S16 PLANNING APPLICATION
APPROVED TONG YAN SAN TSUEN OZP NO. S/YL-TYST/14

**Section 16 Planning Application for Proposed Minor Relaxation of
Building Height and Plot Ratio Restrictions
for Permitted Public Housing Development at
Long Bin, Yuen Long
(Application no. A/YL-TYST/1285)**

Reference is made to the captioned Section 16 application received by the Town Planning Board on 27.9.2024 and the comments received from Planning Department dated 15.10.2024, 24.10.2024, 30.10.2024, 31.10.2024, 4.11.2024, 6.11.2024 and 13.11.2024. We submit herewith the table summarizing HD's responses to the comments as well as the replacement pages and illustrative drawings to substantiate the application.

DO NOT SCALE DRAWING. CHECK ALL DIMENSIONS ON SITE.
ALL RIGHTS RESERVED.
© OVE ARUP & PARTNERS HONG KONG LIMITED.

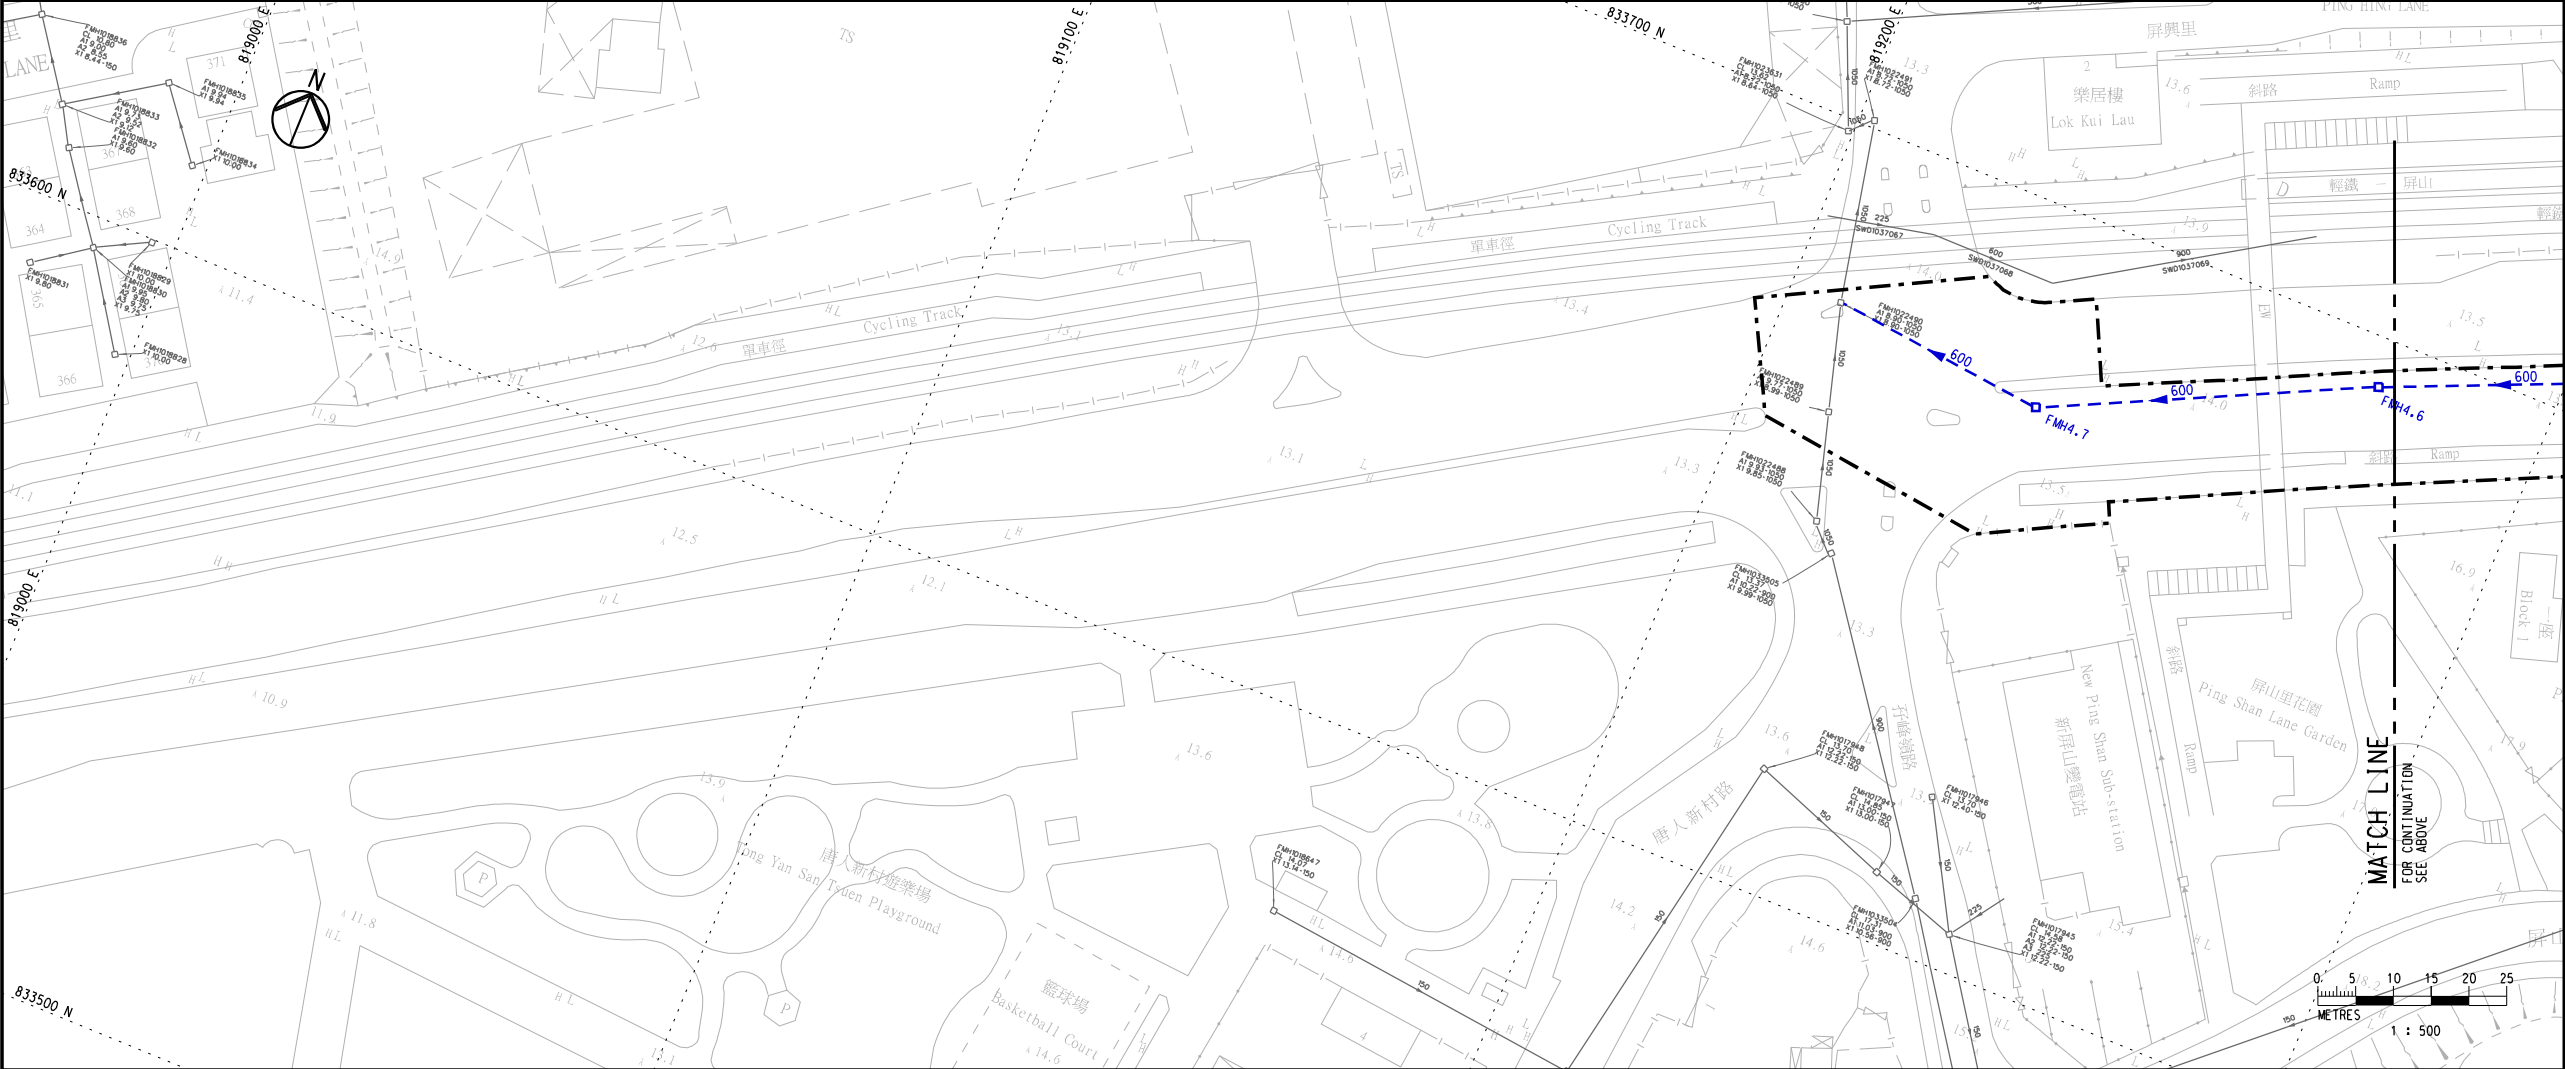
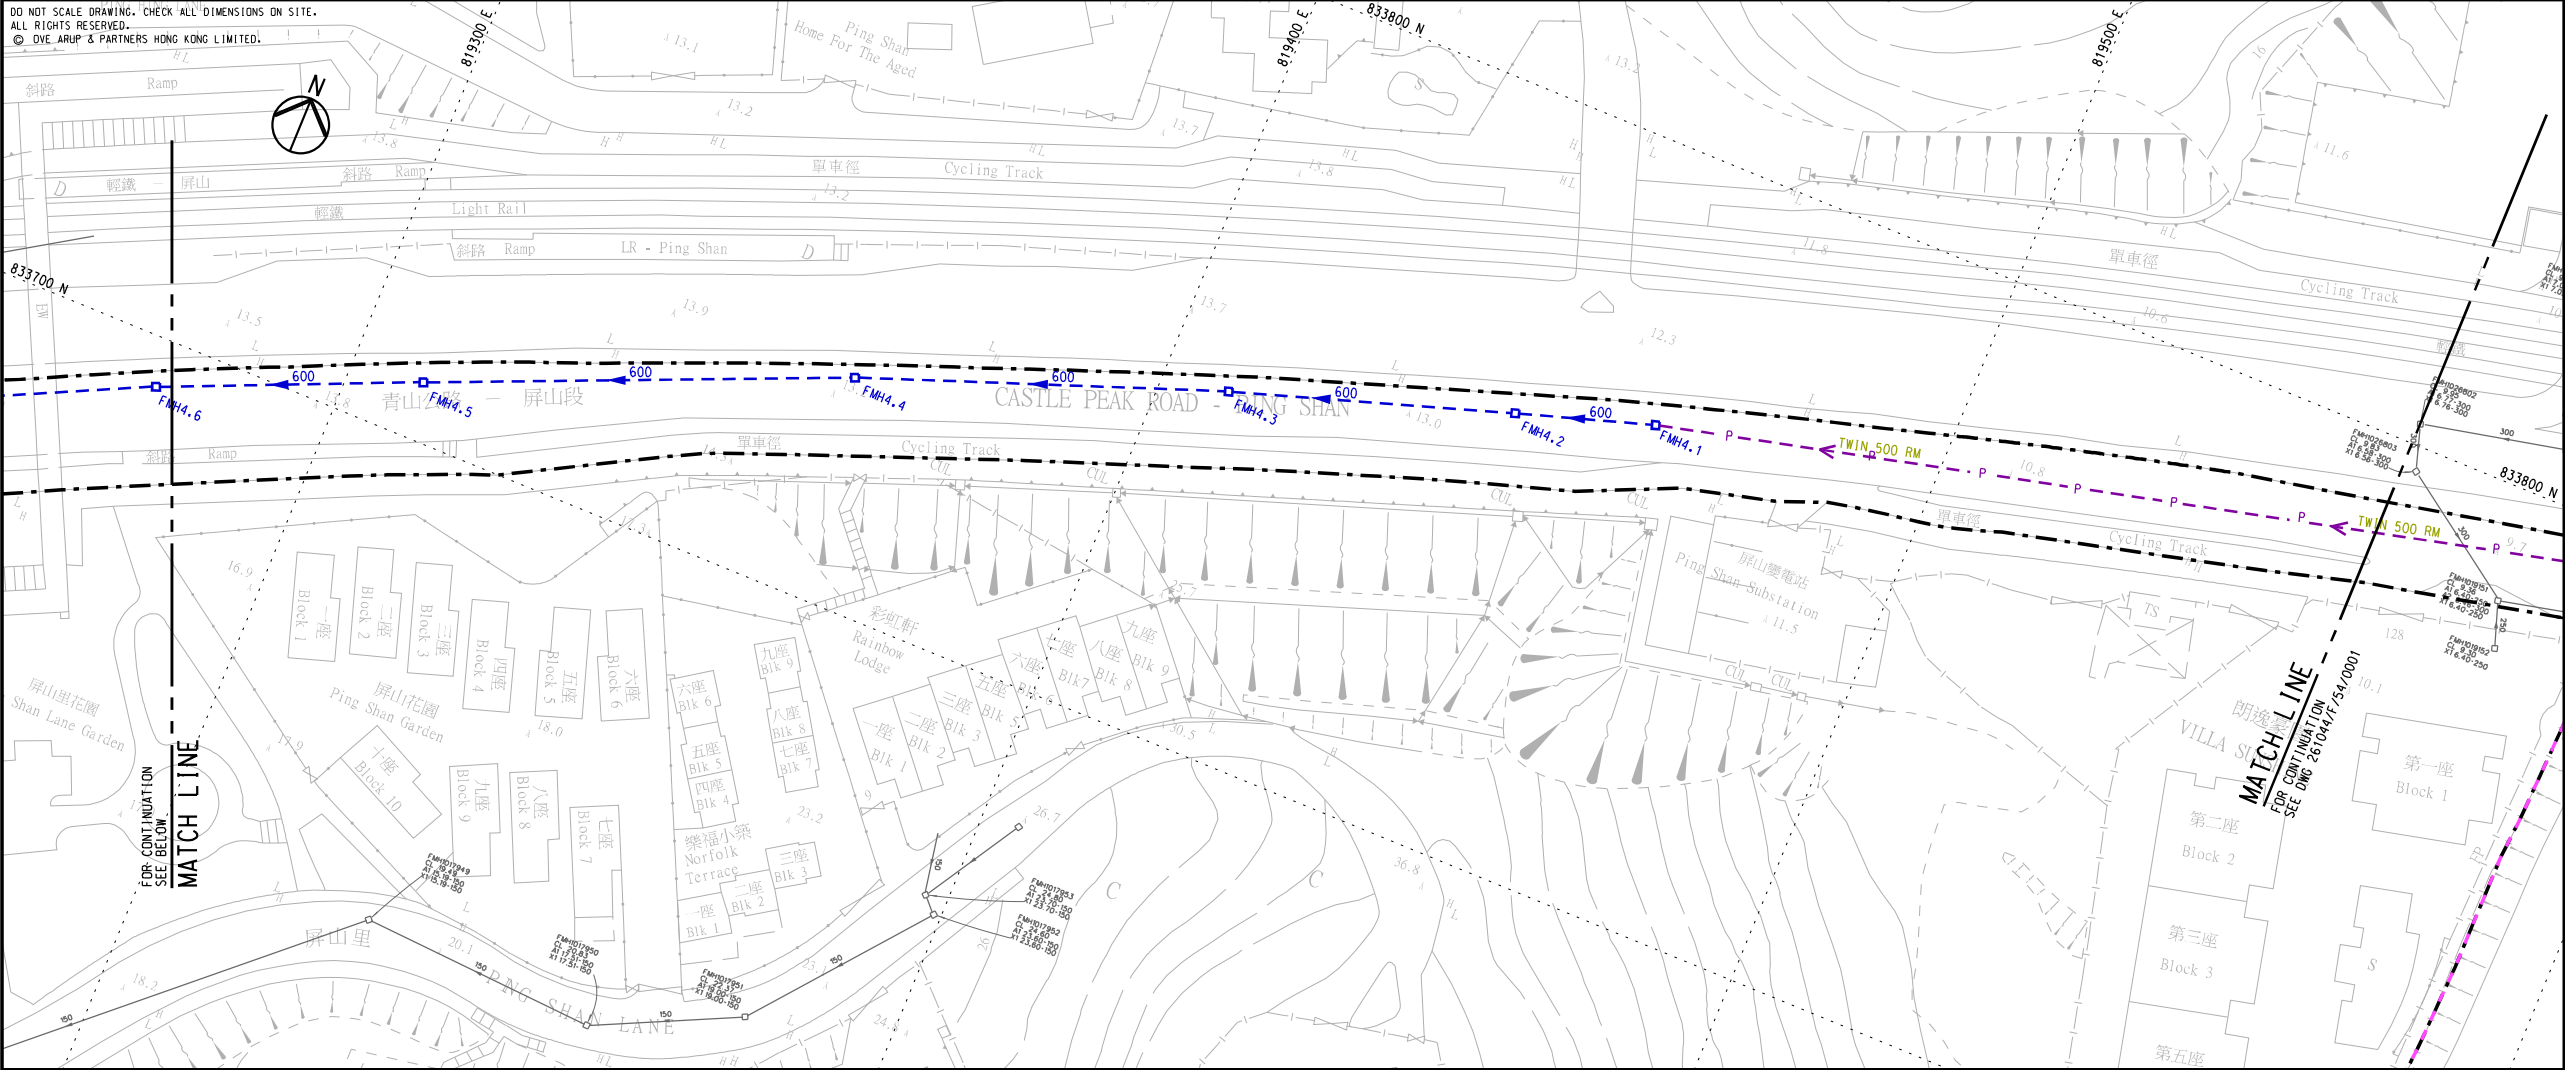
Comments	Responses
	<p><u>Sewerage Impact Assessment (SIA)</u></p> <p>(d) Appendix A – Please provide a plan showing the sewerage discharge path from the application site and the proposed sewerage system for review. The applicant should also check and ensure the hydraulic capacity of the existing sewerage facilities would not be adversely affected by the captioned development.</p>	<p>As elaborated in the Review of SIA, there is only a slight increase of Average Dry Weather Flow (ADWF) 27 m³/day due to the change of development parameters, which constitutes around 0.4% additional total ADWF of Phase 1, 2 & 3 than that determined in the approved Final SIA Report under CE 75/2017 (CE). The impact due to the change of development parameters is therefore considered negligible.</p> <p>The plans showing the sewerage discharged path (as extracted from CEDD's approved Final SIA Report (REP-010-02)) are attached in Attachment 3 which show the proposed sewers constructed along Long Tin Road and connected to a proposed sewage pumping station.</p> <p>The Review of SIA has demonstrated that the hydraulic capacity of the existing sewerage facilities would not be adversely affected by the captioned development.</p>

3. Figure 2: please show the proposed sewer in the layout plan.	Please refer to Attachment 3 for the plans showing the proposed sewers (as extracted from the approved SIA study of CE 75/2017 (CE)).

DRAWING NO.
YL43/S16/A/LO-02

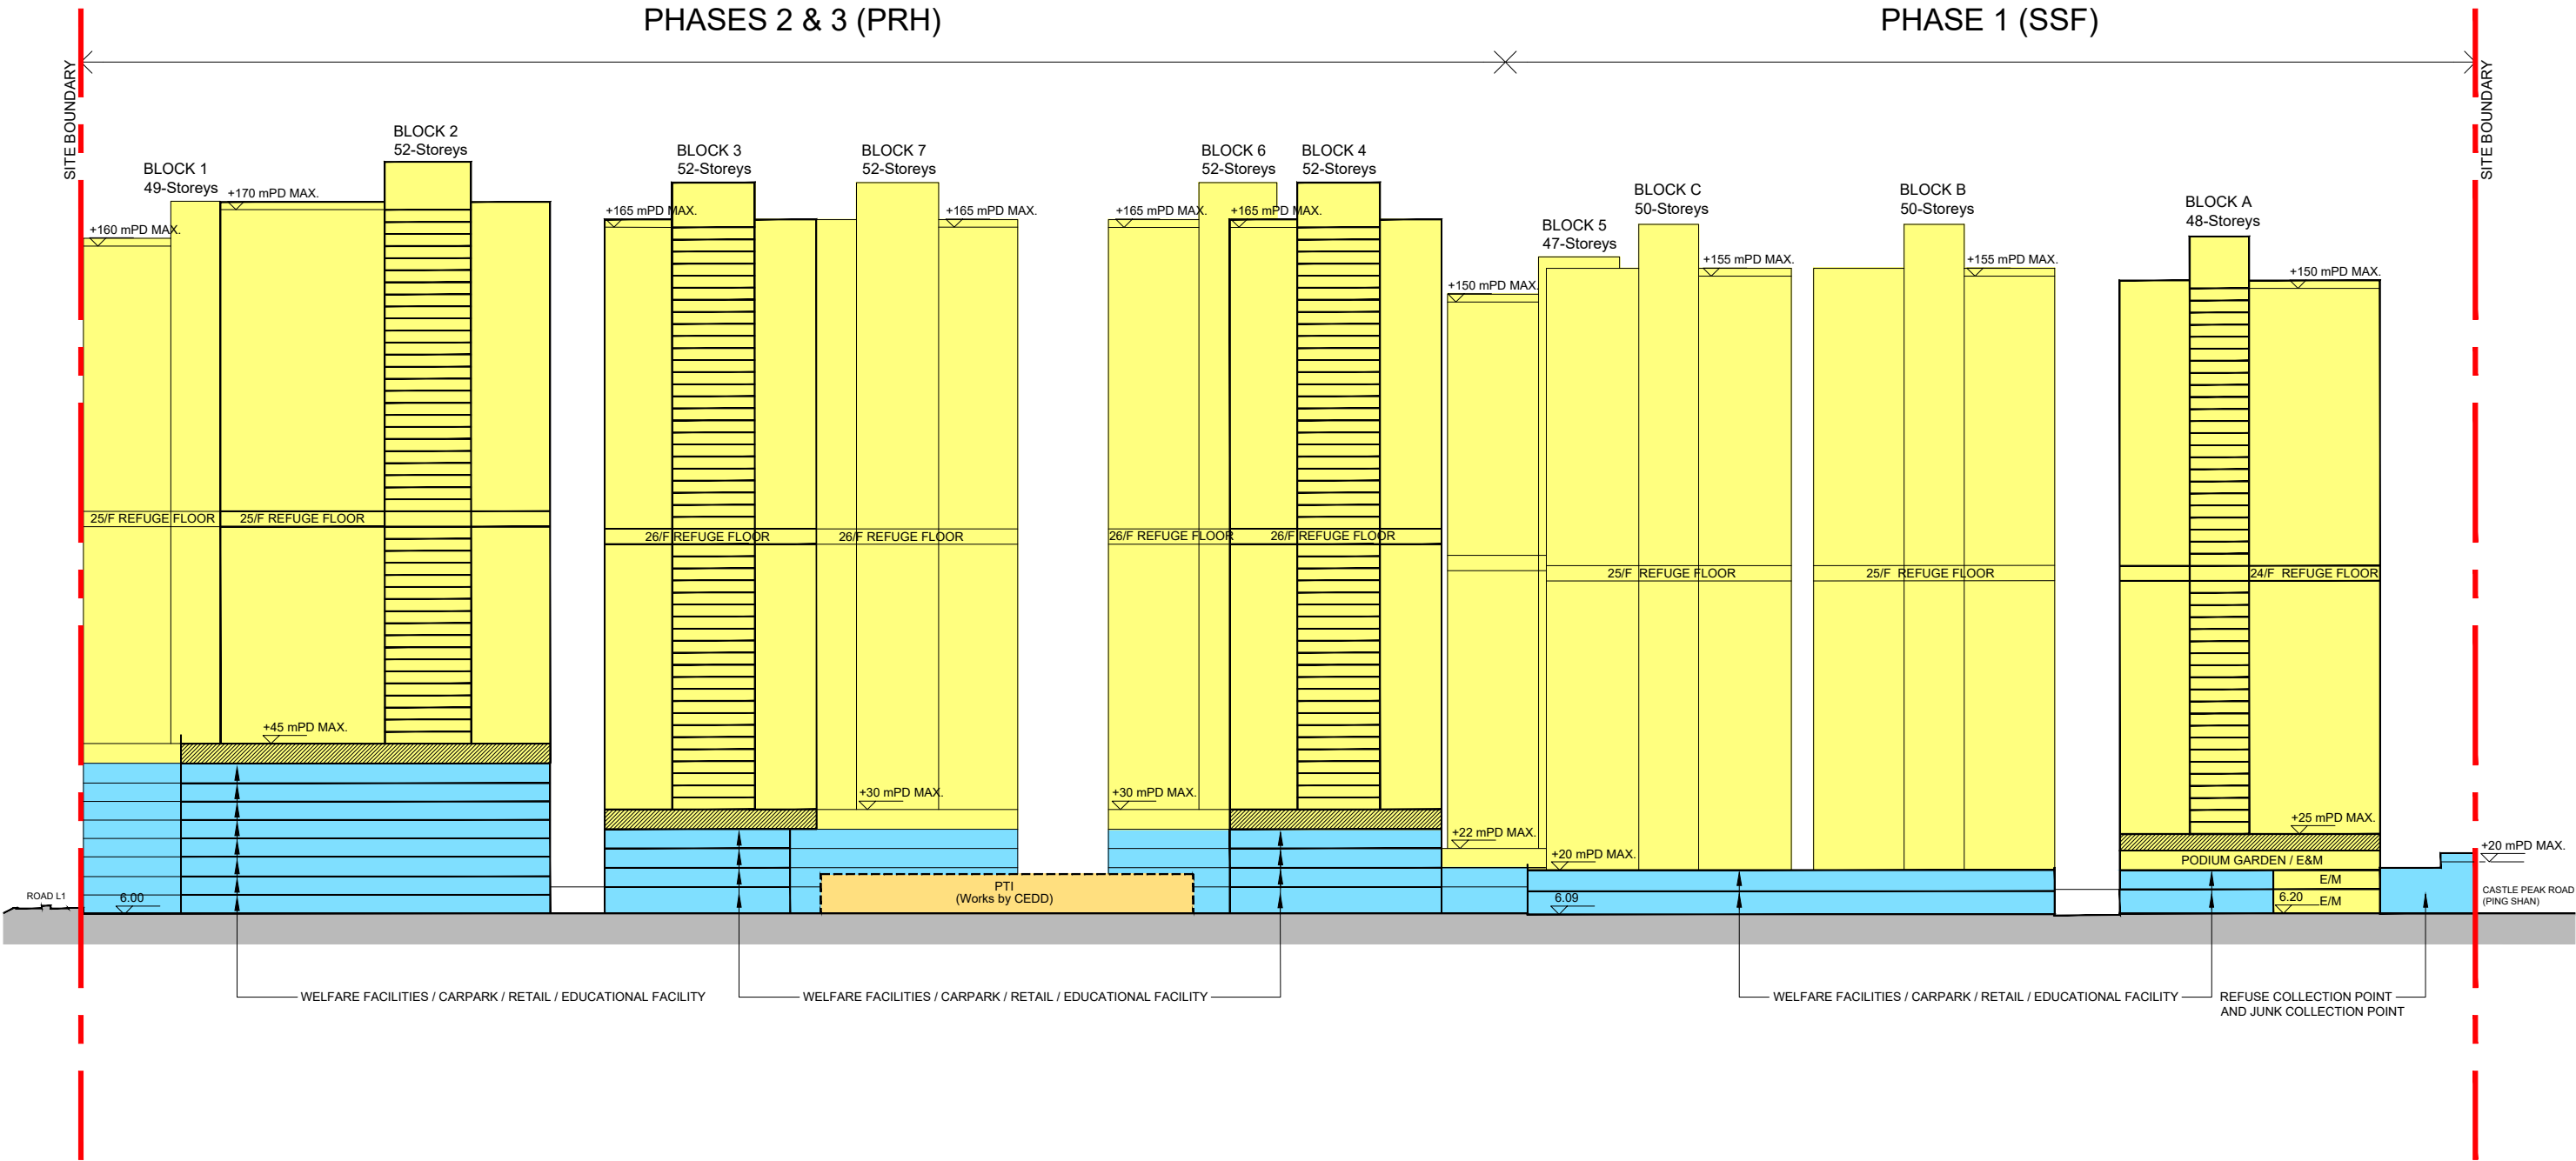
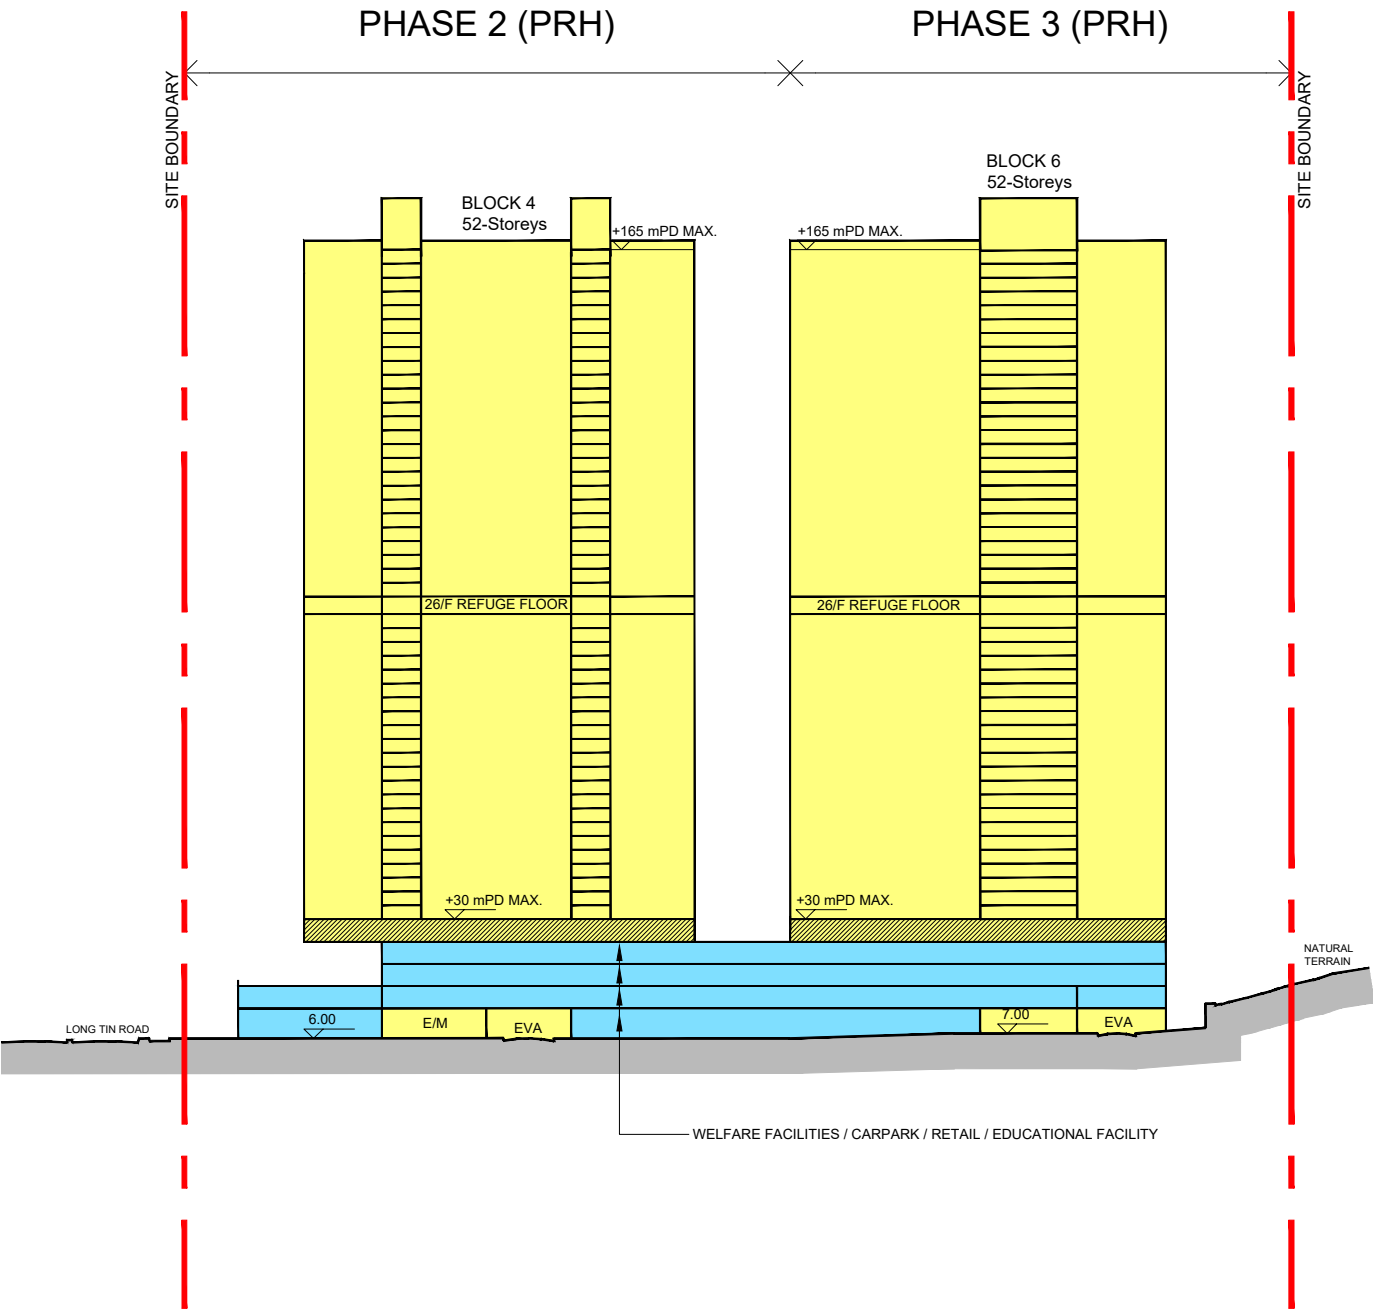
7.	<u>Tuen Mun & Yuen Long West District Planning Office, Planning Department</u> (13.11.2024)	
	<u>Figures 2 to 4 of the Supporting Planning Statement</u> - Please revise the legend for podium and non-domestic blocks to “Welfare Facilities / Carpark	Noted. Please refer to the revised Figures 2 to 4 in Attachment 4 .
